MOBILITY MANAGEMENT PLAN

PROPOSED MIXED-USE DEVELOPMENT  
AT THE FORMER GALLAHER'S SITE,  
AIRTON ROAD, TALLAGHT, DUBLIN 24

**DOCUMENT NO: 19.136 – MMP – 02**

**Stage 1 Road Safety Audit (for Planning)**

**Figure 4.3: Footways in the Vicinity of the Proposed Vehicular Access on Airton Road**

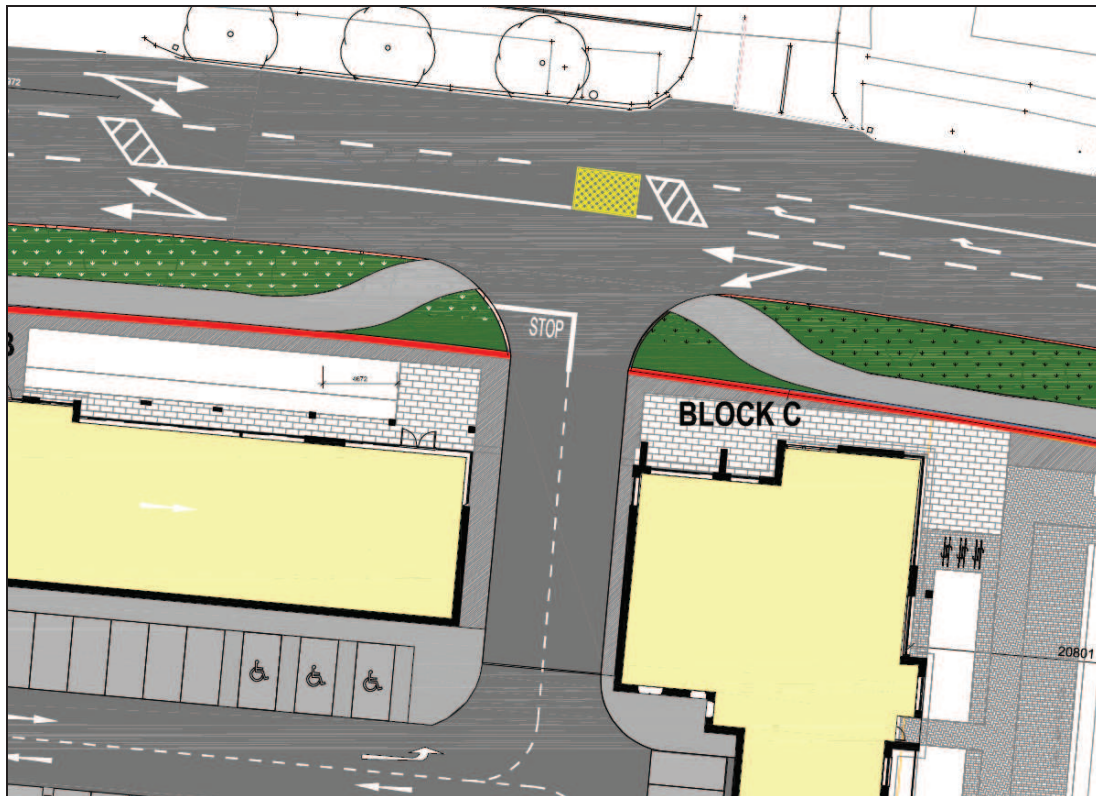
The drawings provided for audit indicate footways in the vicinity of the proposed vehicular access on Airton Road which appear to direct pedestrians from footpaths set back from the carriageway to a crossing location in front of the Stop line immediately adjacent to the Airton Road carriageway (refer to Figure 4.3). Motorists turning from Airton Road into the development may not anticipate pedestrians crossing at this location, which may potentially lead to conflict between vehicles and non-motorised users.

The drawings provided for audit indicate footways in the vicinity of the proposed vehicular access on Airton Road which appear to direct pedestrians from footpaths set back from the carriageway to a crossing location in front of the Stop line immediately adjacent to the Airton Road carriageway (refer to Figure 4.3). The alignment of the footway indicated on the drawings would appear to direct pedestrians into Airton Road, rather than to a safe crossing of the access arrangements. This may cause pedestrians, particularly the visually impaired, to enter the carriageway in an inappropriate manner and potentially coming into conflict with vehicles.

4.1.4	Y	Y	These drawings have been updated and revised. Please see drawings which have been issued as part of this response. The pedestrian route has now been set-back. The crossing has been designed per DMURS guidelines.	Y See 'Note 1' below

**Figure 4.4: Apparent Discrepancies in Proposed Road Markings on Airton Road**

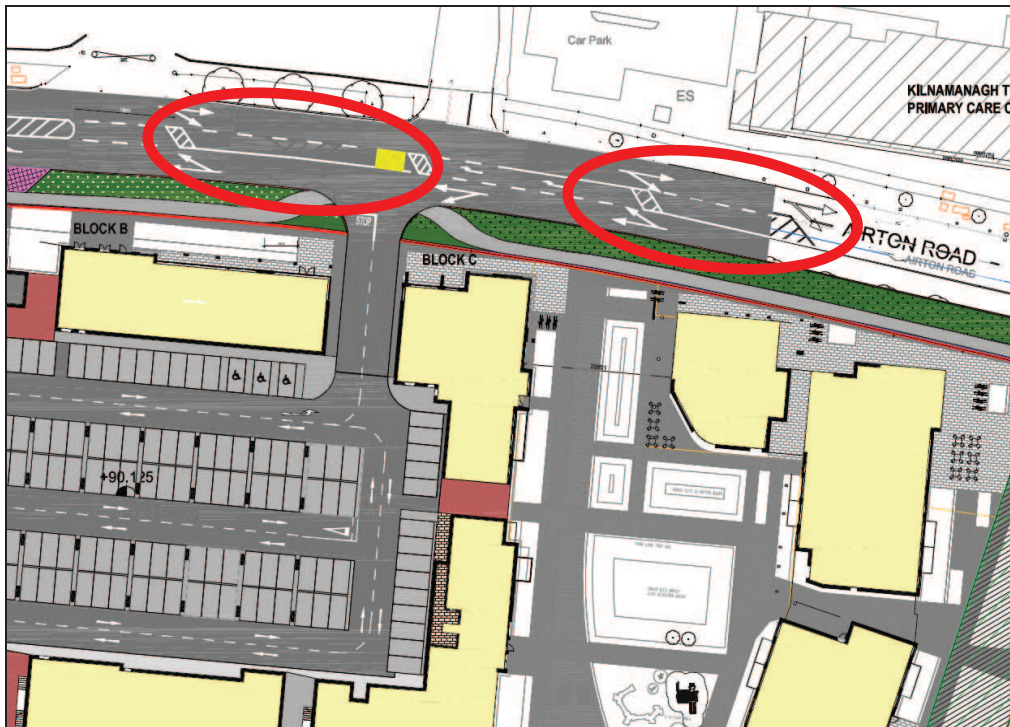
The drawings provided for audit appear to have discrepancies in relation to the proposed road markings on Airton Road. This includes missing right-turn lane markings and unclear ghost island hatching markings (refer to Figure 4.4). Without clear and appropriate road markings road users may become confused as to how to progress through the proposals and come into conflict with other road users.

4.1.7	Y	Y	Addressed with updated drawing package. The new site entrance will be designed per DMURS guidelines.	Y See 'Note 1' and 'Note 2' below
4.1.8	Y	Y	Recommendation accepted. Pedestrian access to facilities within the undercroft parking will be revised as part of the Stage 3 ABP drawing submission.	Y

**Figure 4.5: Pedestrian Access Route within the Undercroft Area Not Indicated Between the Proposed Cycle Parking Area Located at the Centre of Block A and the Access Door to the Southern Part of Block A**

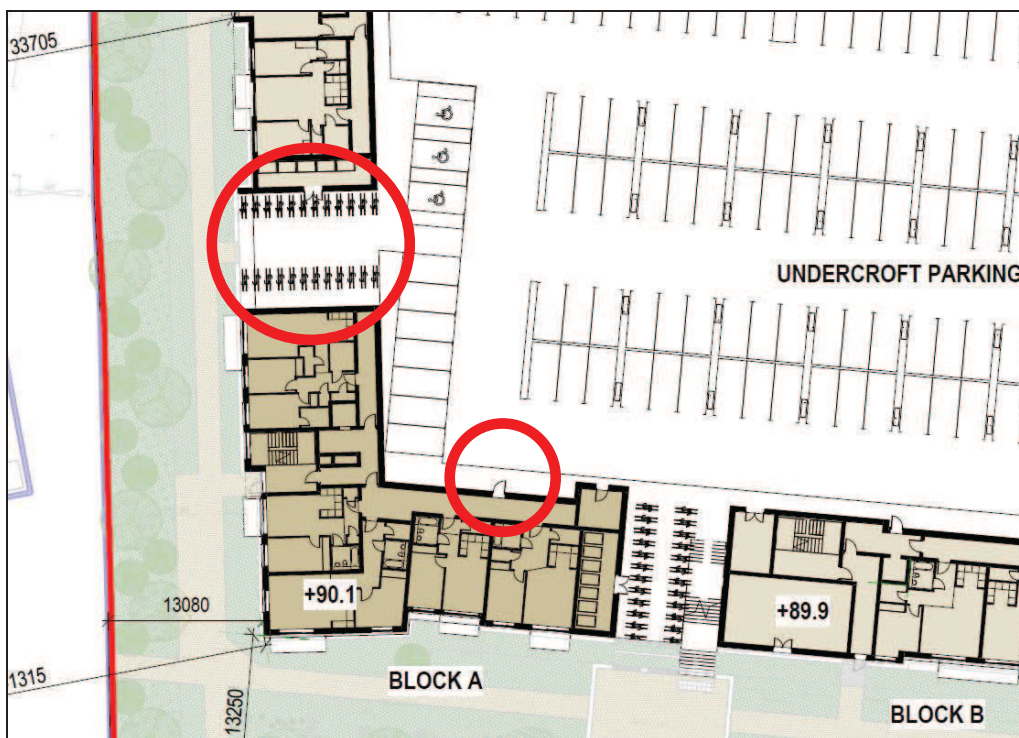
The drawings provided for audit do not clearly indicate a pedestrian access route within the undercroft area between the proposed cycle parking area located at the centre of Block A and the access door to the southern part of Block A (refer to Figure 4.5). This may lead to non-motorised users inappropriately navigating the car park at inappropriate locations and potentially coming into conflict with vehicular traffic.
